## Planning Application Information Sheet

**Application Type:** Development Variance Permit

**File Number:** 3090-20/20260008

**Location:** 3774 Bowers Lake Rd

Figure 4: Cross-section of the site, based on Lidar data and site observations, showing the Q200 elevation in relation to the berm and stream, and proposed rip rap.

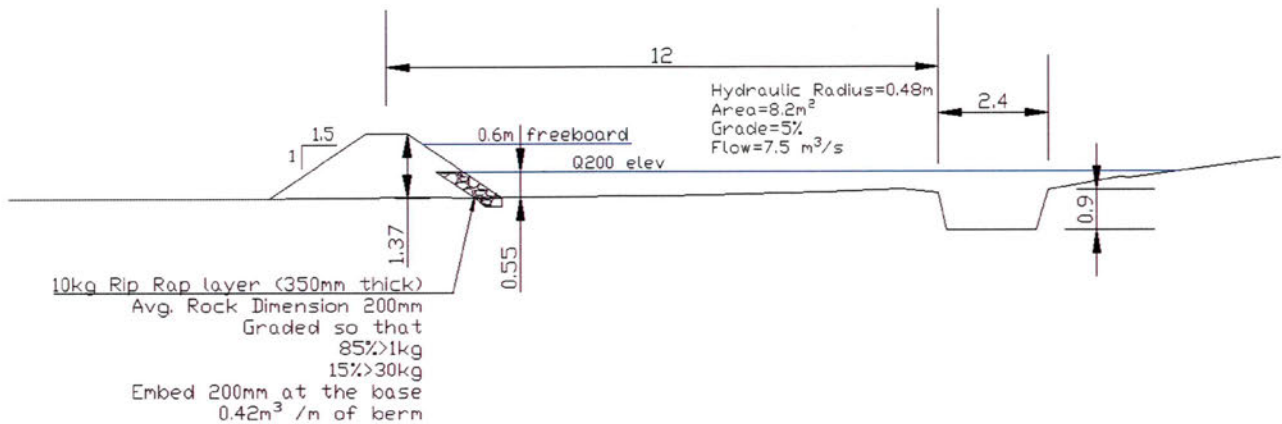
A comment has been received by the public regarding the proposal. The comment is in support of the application however does raise two concerns: disturbance of the watercourse and its impact on water quality and the quality of construction of the berm. The comment requests that work on the berm be limited to the watercourses low-flow season (late summer or early fall) and that the berm be inspected by an independent third party.

The construction of the proposed berm and any creek-adjacent works should be reviewed and signed off by an independent qualified professional (e.g., hydrologist or professional engineer) to confirm that the work meets the design specifications and protects the creek's flow rate.

1. Extend the berm 6m upstream to where the stream bank height exceeds 1.5m in height, as indicated in Figure 5.
2. Add 10kg class Rip Rap to the berm (there is currently none) as indicated in Figure 4.
3. Repair any gaps in the berm.
4. A qualified professional should inspect the final berm to confirm compliance to these recommendations.
